Date: **January 30, 2026**
Project: **Shageluk Bulk Fuel Upgrades**
Solicitation No.: **ITB 26030**
Addendum No.: **02**

The modifications directed by this Addendum Two are described on this page.

SHAGELUK BULK FUEL UPGRADES COLOCATED TANK FARM ELECTRICAL PLAN

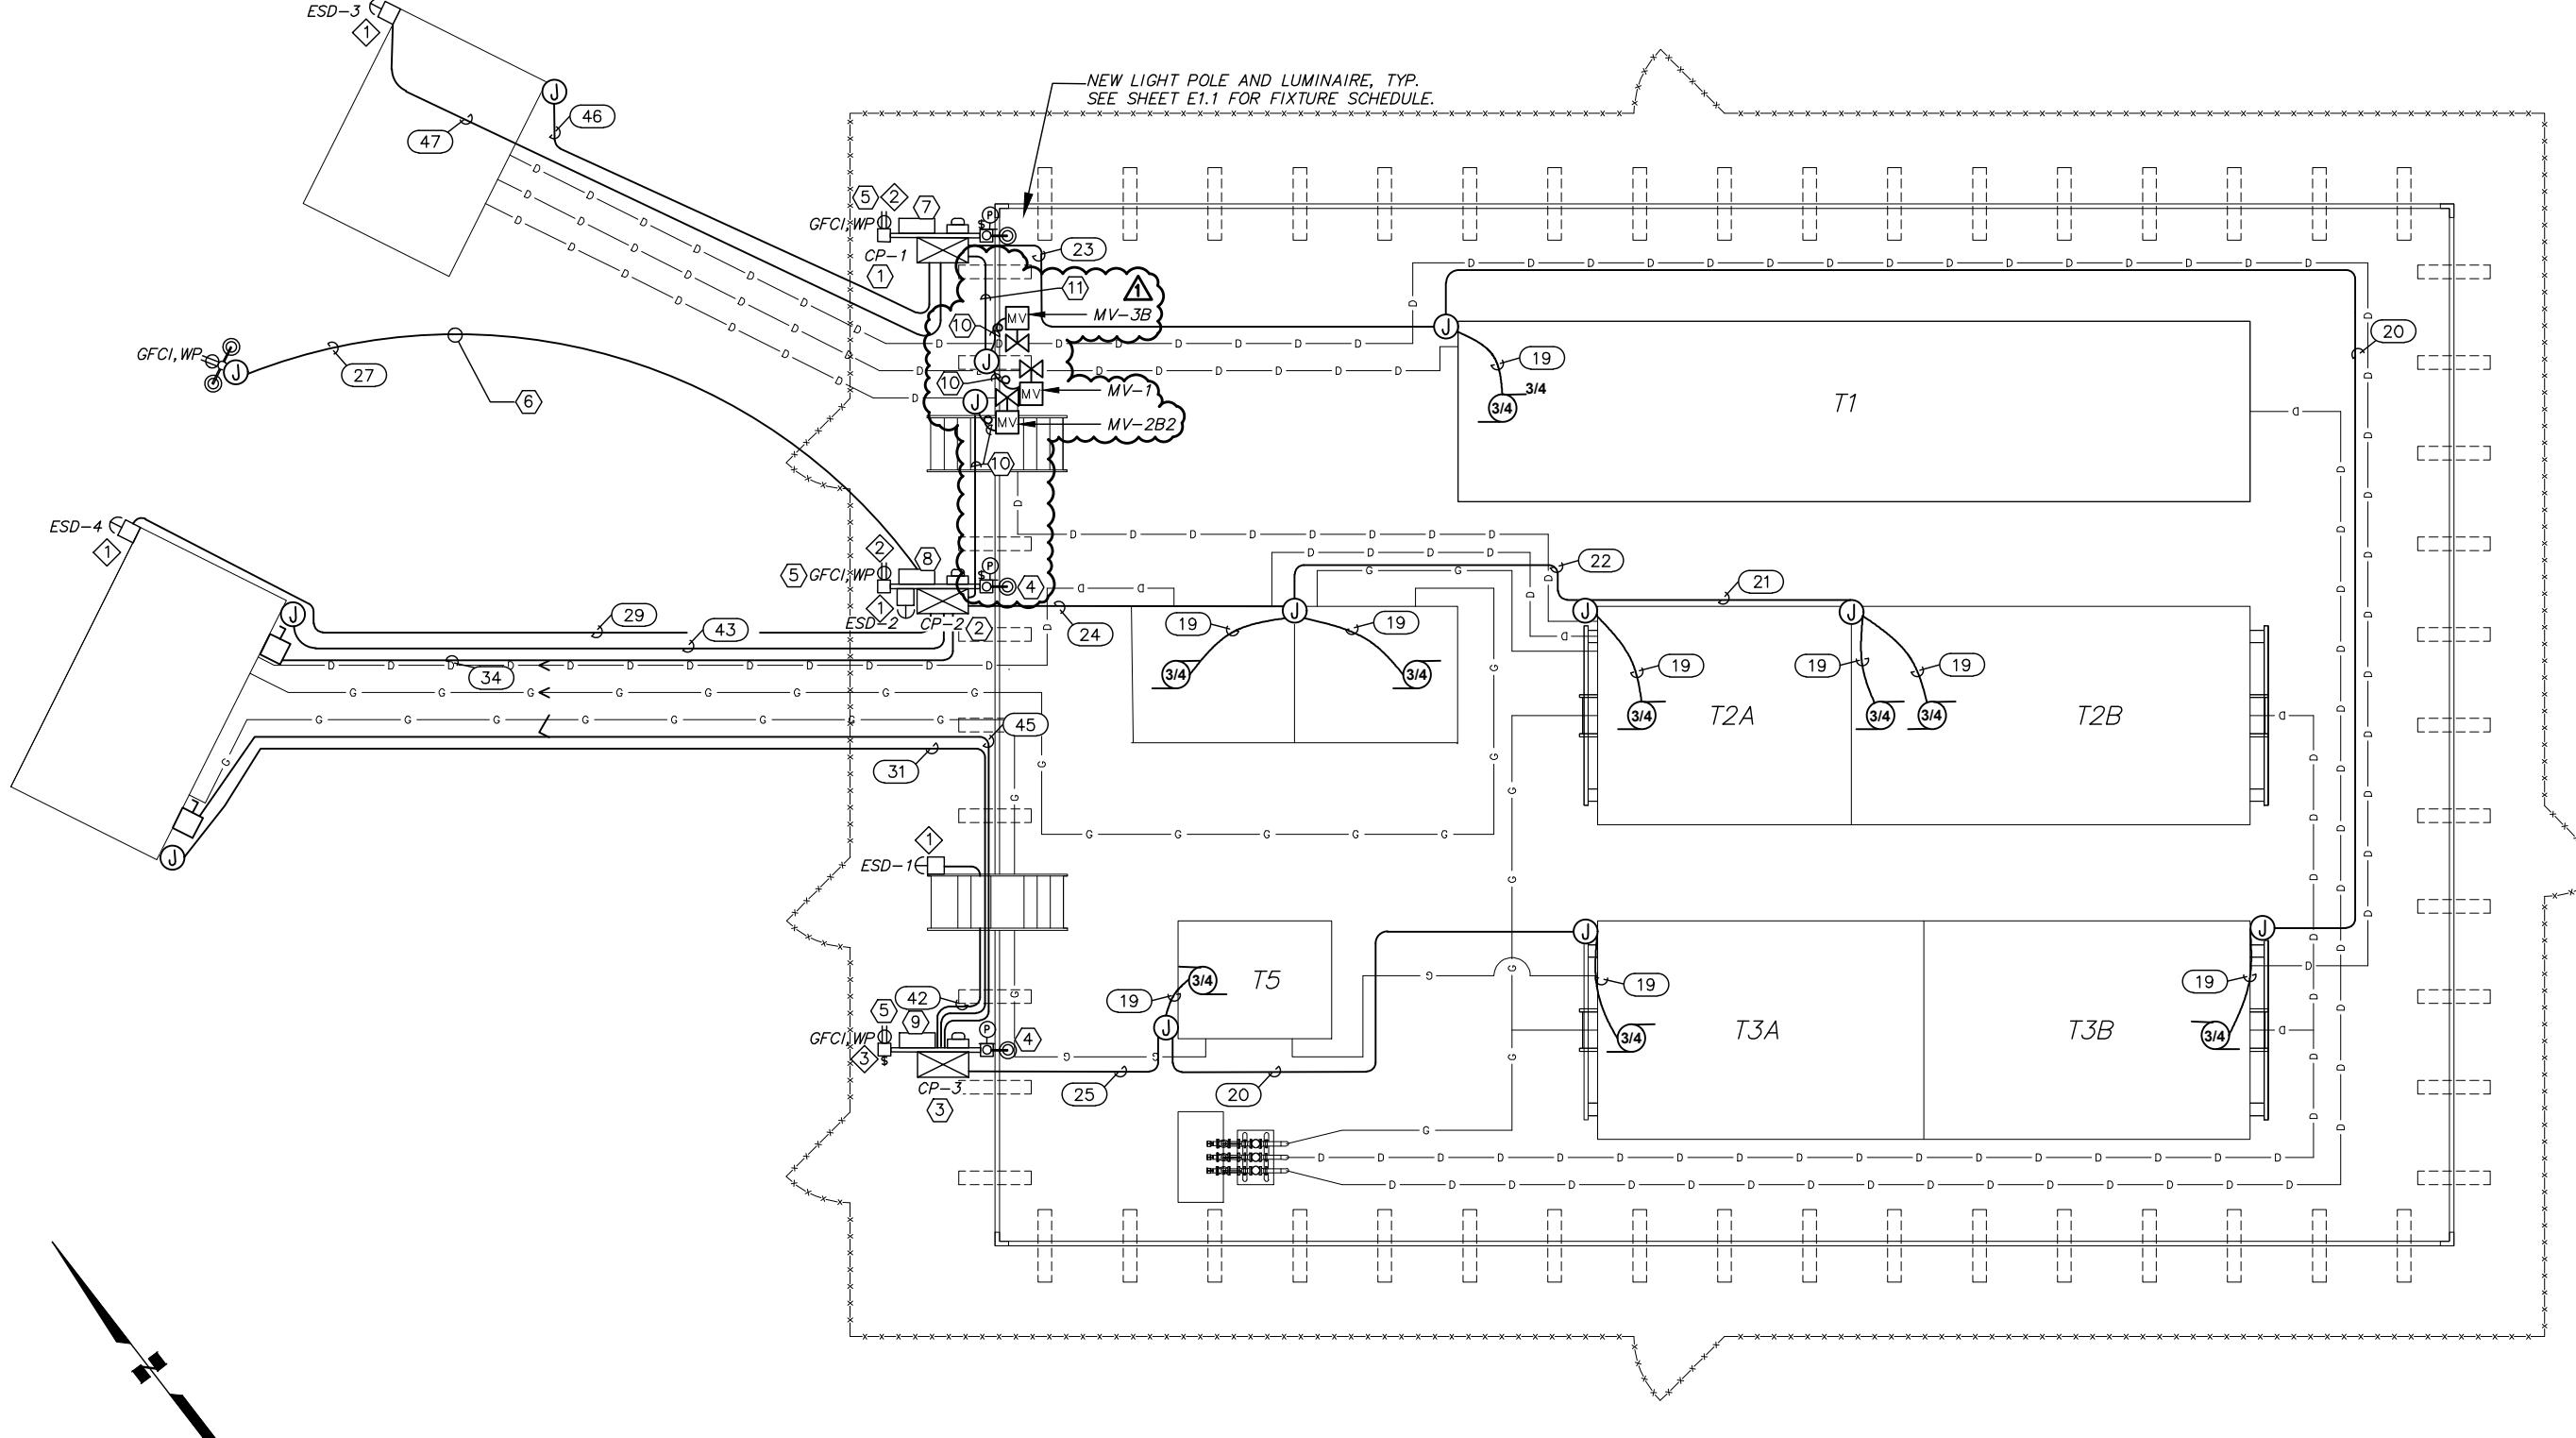
- 3. Question:** Sheet G1.6 shows MV-1, MV-2B2, and MV-3B. These motor valves are not shown on C1.8 pr E2.4. Please revise the drawings to show the complete system.

NO.	REVISION	BY	DATE
Plot Date	A ISSUED FOR BIDDING	BC	3/31/25
Designed	△ ADDED MOTORIZED VALVES	TK	1/29/26
Drawn	ESC,JB		
Approved	BC

Answer: Design Drawings E2.3 and E2.4 are hereby replaced with revised sheets of the same numbers included with this Addendum. All revisions are clouded and identify the required motorized valves and flow switches.

SHAGELUK BULK FUEL UPGRADES
COLOCATED TANK FARM
INSTRUMENTATION PLAN
SHAGELUK, ALASKA

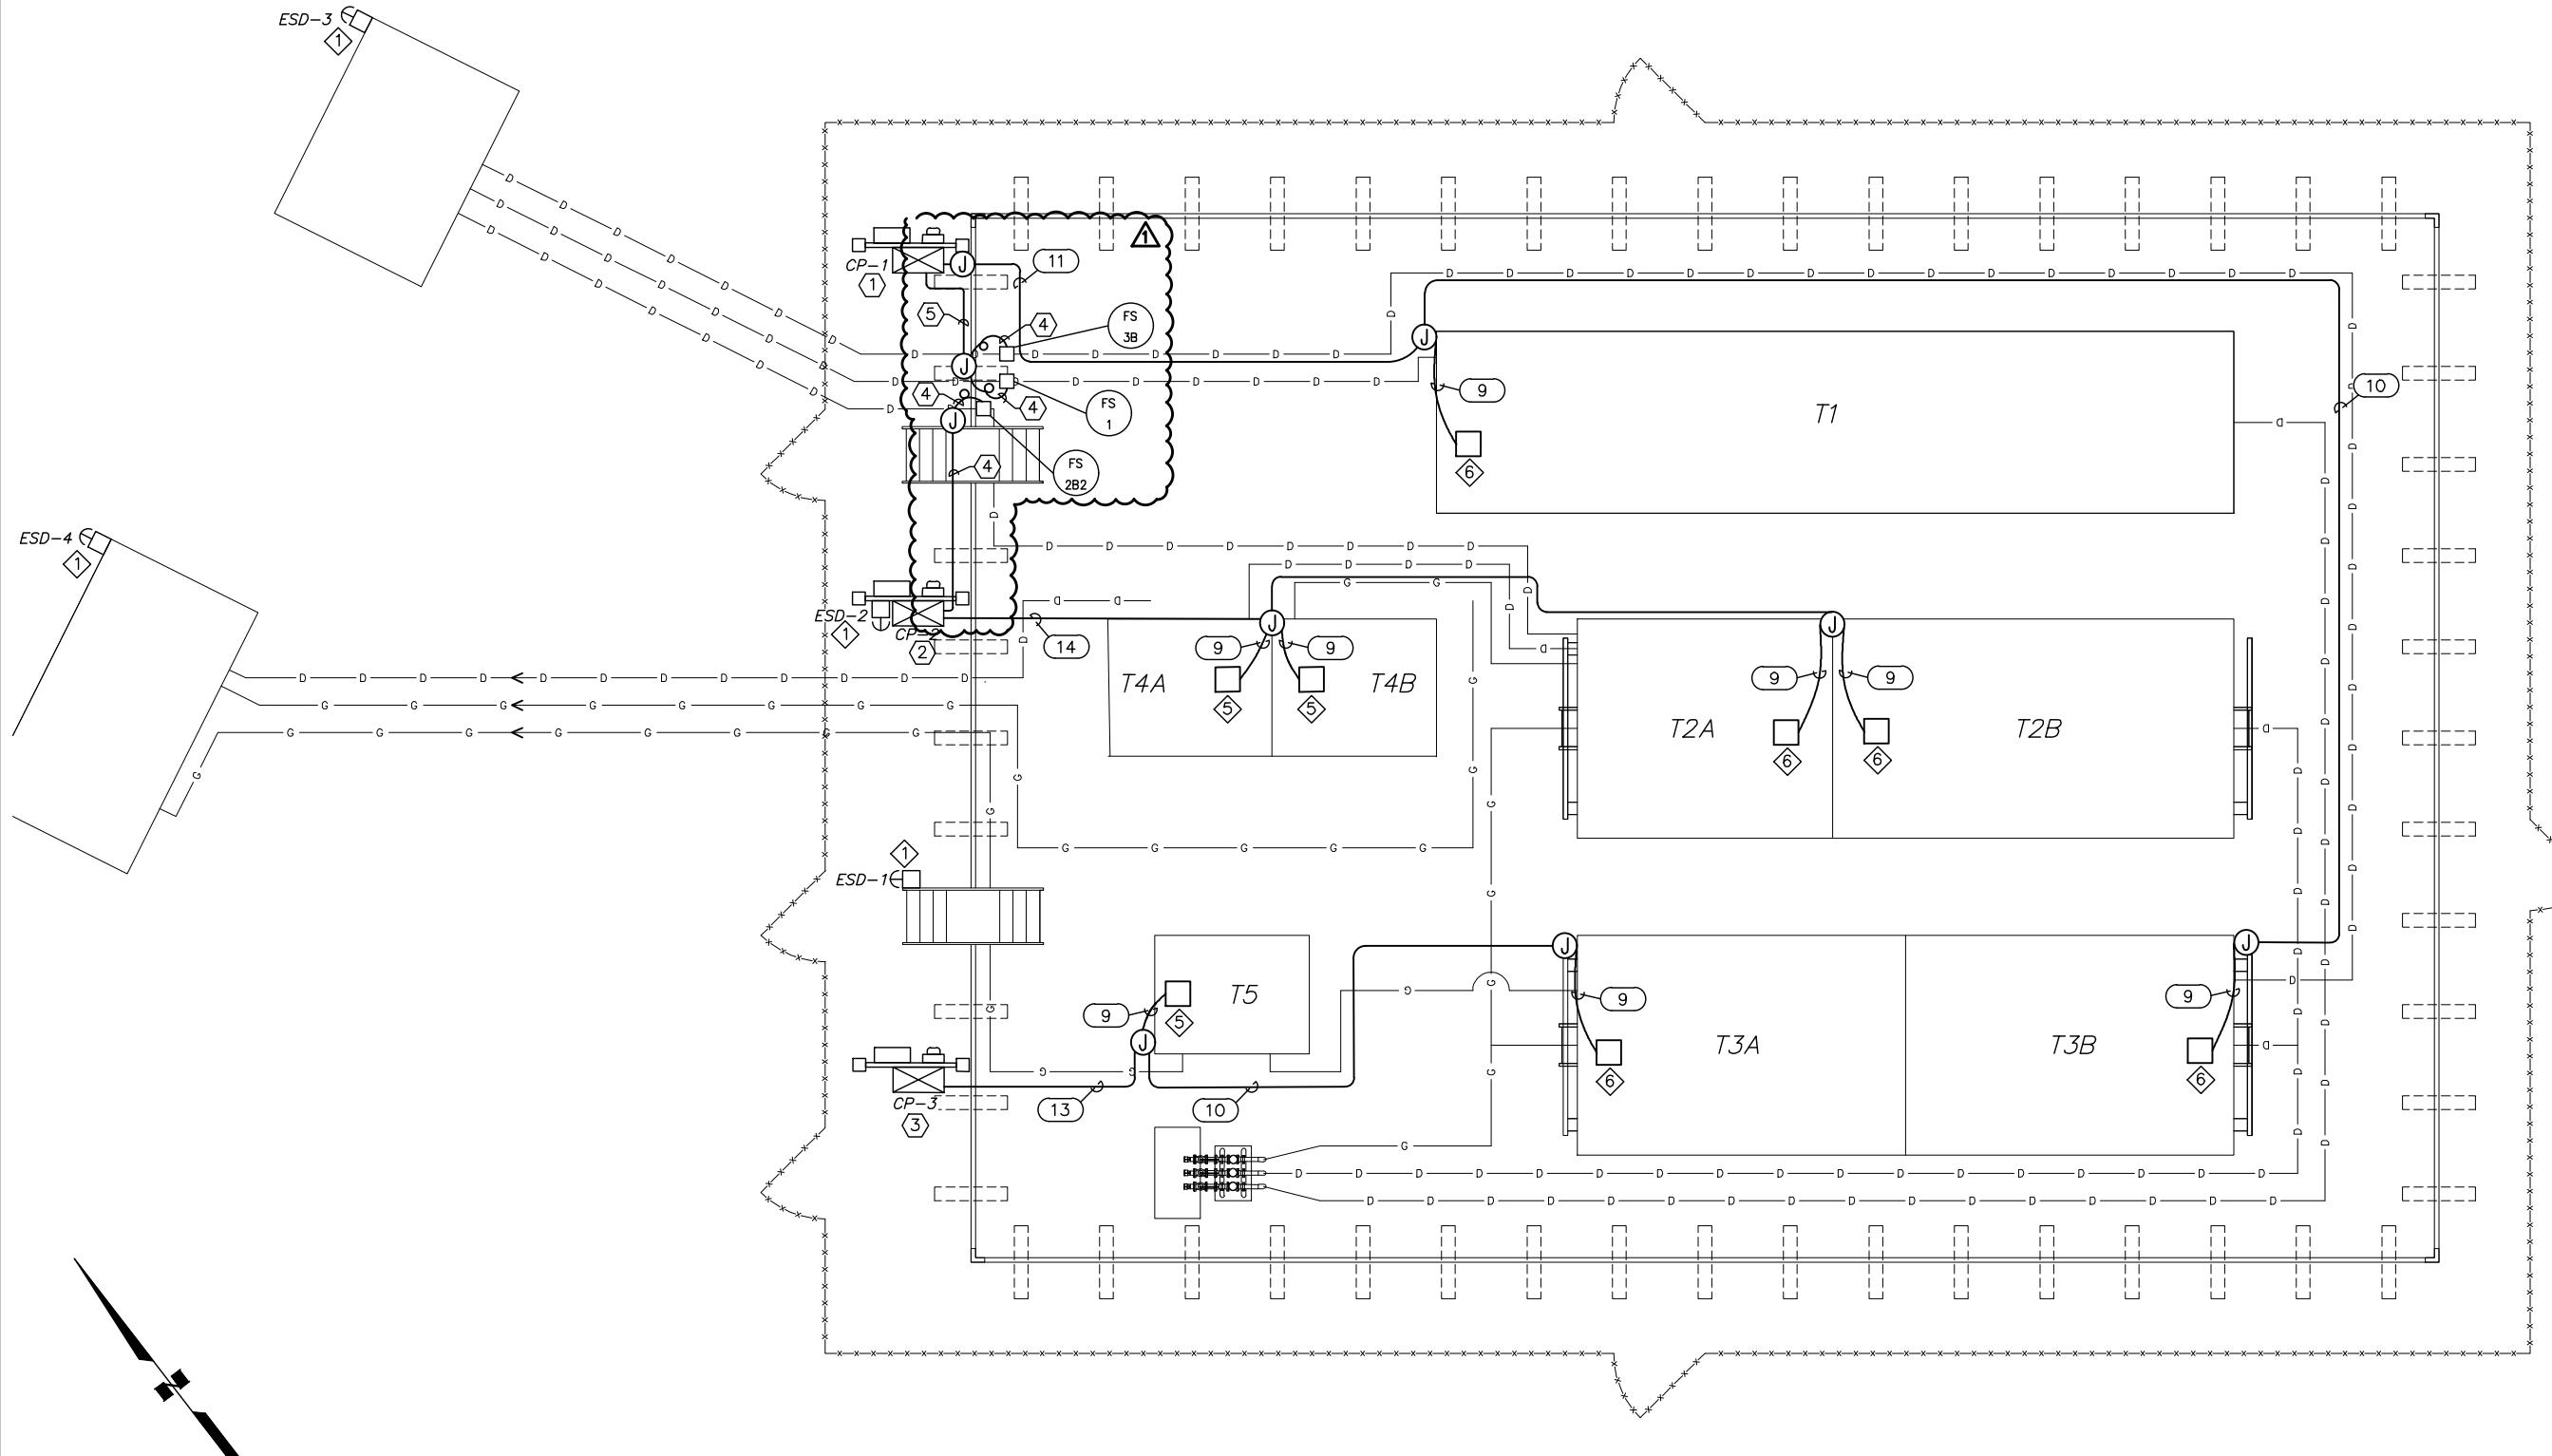
NO.	REVISION	BY	DATE
A	ISSUED FOR BIDDING	BC	3/31/25
	ADDED FLOW SWITCHES	TK	1/29/26
Plot	1/29/26		
Date			
Designed	EC		
Drawn	ESCJB		
Approved	BC
